## ADDENDUM NO. 1

**TO: PLANS AND SPECIFICATIONS FOR STATE OF MISSOURI  
Replace Roofs & Renovate Building – Sheep Pavilion  
Missouri State Fairgrounds  
Sedalia, Missouri  
PROJECT NO.: F1907-01**

REPLACE ROOFS &  
RENOVATE STOCK PENS  
SHEEP PAVILION

ADDENDUM #1

**SECTION THRU EIFS SYSTEM**

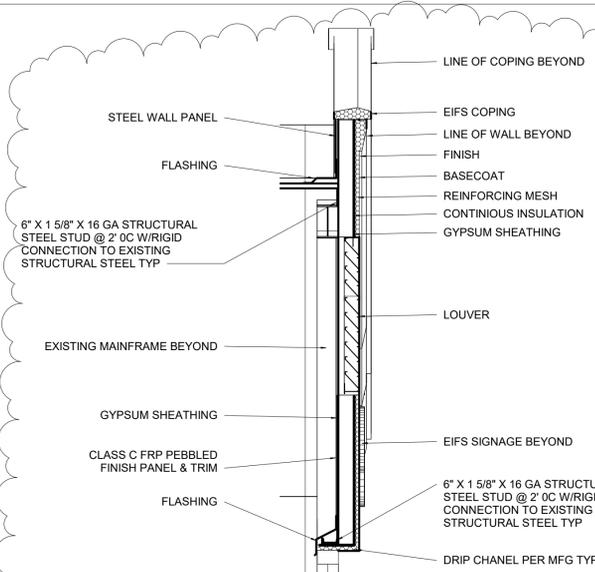
1. Sheet A-211
  - a. ADD Detail 4 to Sheet A-211. See attached revised Sheet A-211.
2. Sheet EP-101
  - a. ADD the following sentence to Key Note 6: “MDP to be turned over to Owner upon removal.”
